Comments on Puget Sound Energy's 2017 Integrated Resource Plan

Washington Utilities and Transportation
Commission Docket Nos. UE-160918 & UG-
160919

Prepared for Sierra Club

January 23, 2018

Figure 1. Wind Capital Costs, Lazard Historical and PSE IRP Forecasts

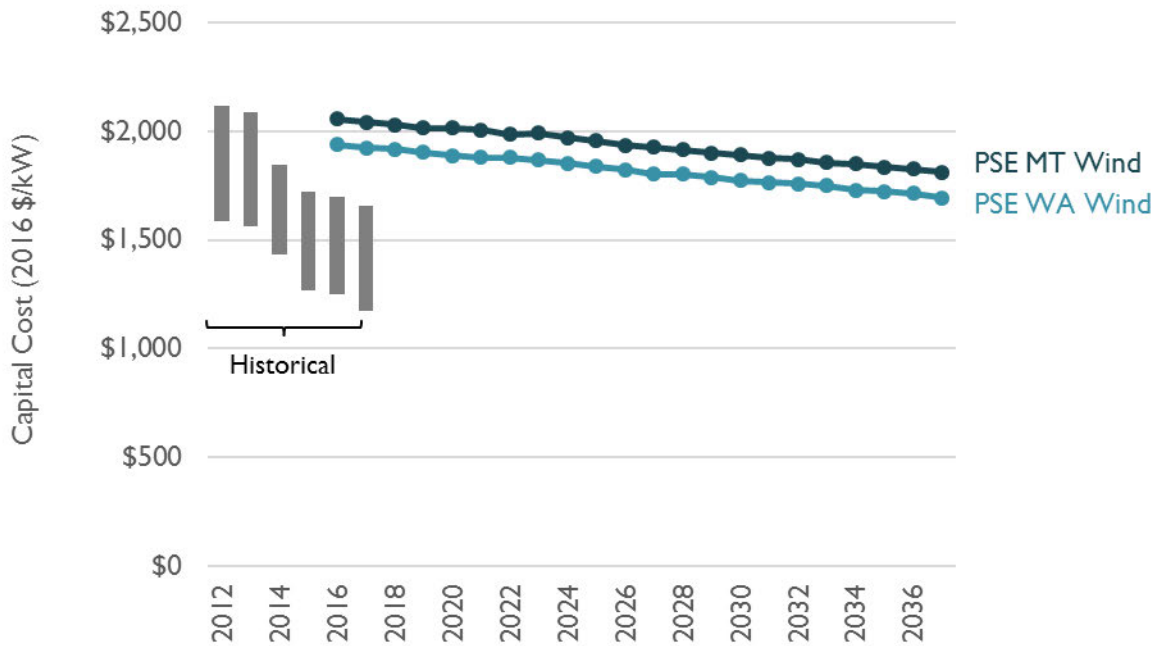
Figure 1 depicts PSE's forecasted capital costs for Washington and Montana wind in comparison to historical Lazard capital cost estimates. This shows that Lazard's estimates of 2017 wind capital costs are 15 percent lower than PSE's Washington wind assumptions and 23 percent lower than PSE's assumptions for Montana wind. Under PSE's projected trajectory, wind capital costs remain above currently achievable levels through 2037.

Figure 2. Solar Capital Costs, Lazard Historical and PSE IRP Forecasts

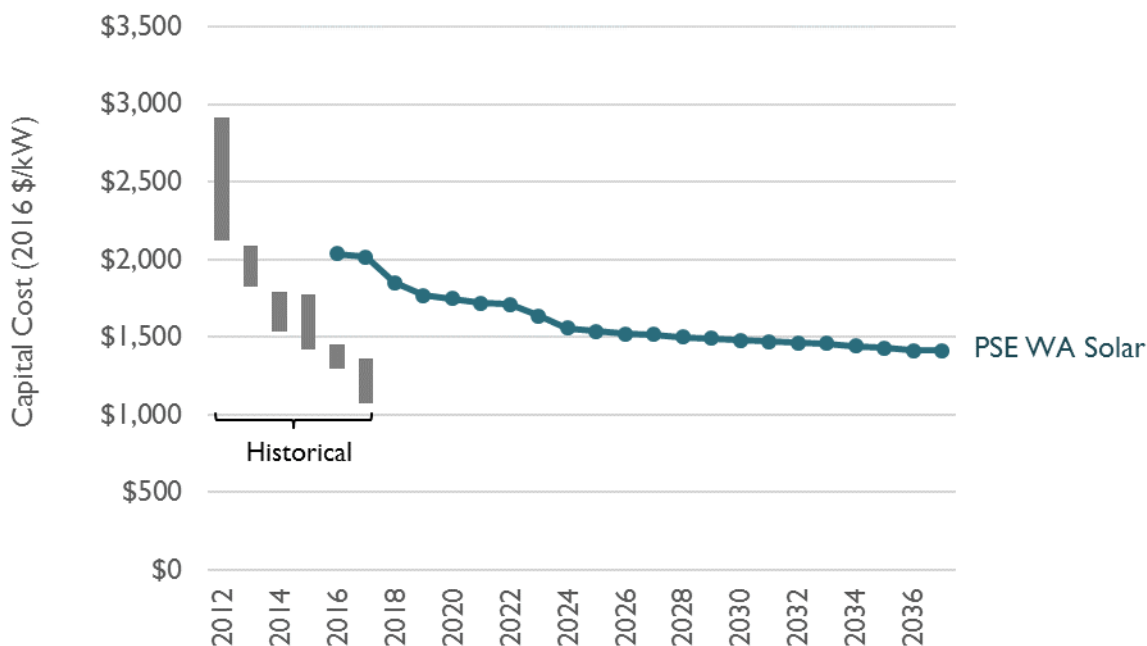
PSE’s solar cost assumptions appear to be even more overstated than its wind costs in the near term. Figure 2 shows that PSE’s cost estimates are about 50 percent too high for 2017. Although PSE forecasts future declines in solar costs, its projection still remains higher than Lazard’s estimate of current costs. Moreover, even PSE’s “lower” solar cost sensitivity assumes capital costs of \$1,755 per kilowatt (kW), about 30 percent higher than current capital costs per Lazard.²¹
